Subject: 1794 Applevue Road (PRE 06/25)

**Materials and Studies Required for PRE 06/25
Application for Zoning By-law Amendment**

Re: Concept Development Application – Submission 2
1794 Appleview Road
Lot 57, Plan 1051, Pickering
North of Dunbarton Road & West of Appleview Road
Applicant: Ashley Yearwood, Planning Peace of Mind Services Inc.
Owner: Leo Perciasepe, Apcom Enterprises Inc.

Subject: Pre-Consultation Request (PRE 06/25)
Proposed Zoning By-law Amendment
1794 Appleview Road

TYPICAL RESIDENTIAL ROOF WATER
INFILTRATION TRENCH

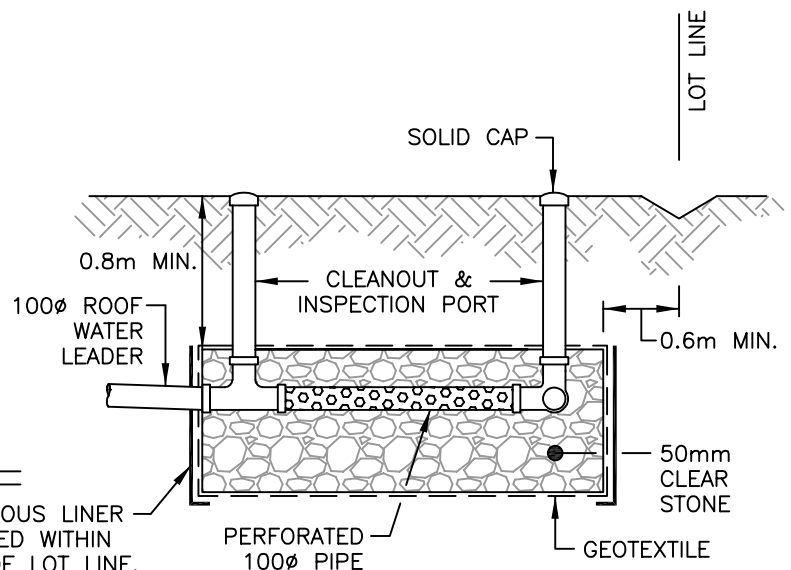
Irina Marouchko, City of Pickering, Manager, Water Resources	<p>The following Water Resources comments and attachment are applicable:</p> <ul style="list-style-type: none"> • Quantity control: in accordance with the Dunbarton Creek watershed criteria, control of post-development peak flow rates to pre-development levels for all storm events up to the 100-year return period is required. The controlled flows from the subject development must be directed towards Dunbarton Creek in accordance with the existing drainage pattern. • Quality and Erosion control: minimum 5mm retention/infiltration the on-site. Low Impact Development (LID) measures shall be designed in accordance with the TRCA & CVC LID SWM Planning & Design Guide and the City's SWM Design Guidelines. Sizing calculations and design information for all proposed LIDs must be provided in the Stormwater Management Design Brief/Letter signed and sealed by a Professional Engineer. Locations and details of the proposed measures must be shown on the Site

Item/ Ref #	Details, Discussion & Conclusion (summary of discussion)
	<p>Servicing/Grading Plan. Refer to the City Standard detail P-1020.</p> <ul style="list-style-type: none"> • All proposed LID measures must be located solely on private property and must be owned and maintained by the property owner. All necessary information regarding the function and maintenance of LID must be included in the purchase agreements. A Section 119 Restrictive Covenant is to be registered on title prohibiting the alteration or removal of the LID measures. • A minimum 450mm depth of amended soils shall be specified for all grassed areas such as back yards, front yards and side yards. Add appropriate notes on the Site Grading Plan. • Foundation/sump pump discharge to the surface or LIDs. <p>Contact: imarouchko@pickering.ca</p>
Arnold Mostert City of Pickering, Manager, Landscape & Parks Development	<p>Landscape & Parks Development Department provides the following comments:</p> <ul style="list-style-type: none"> • The site is heavily treed. An arborist report and tree protection / compensation plan will be required per the City's policy: https://www.pickering.ca/media/00bdc4gn/tree-inventory-preservation-removal-compensation-requirements.pdf • One boulevard tree is required for each lot. <p>Contact: amostert@pickering.ca</p>
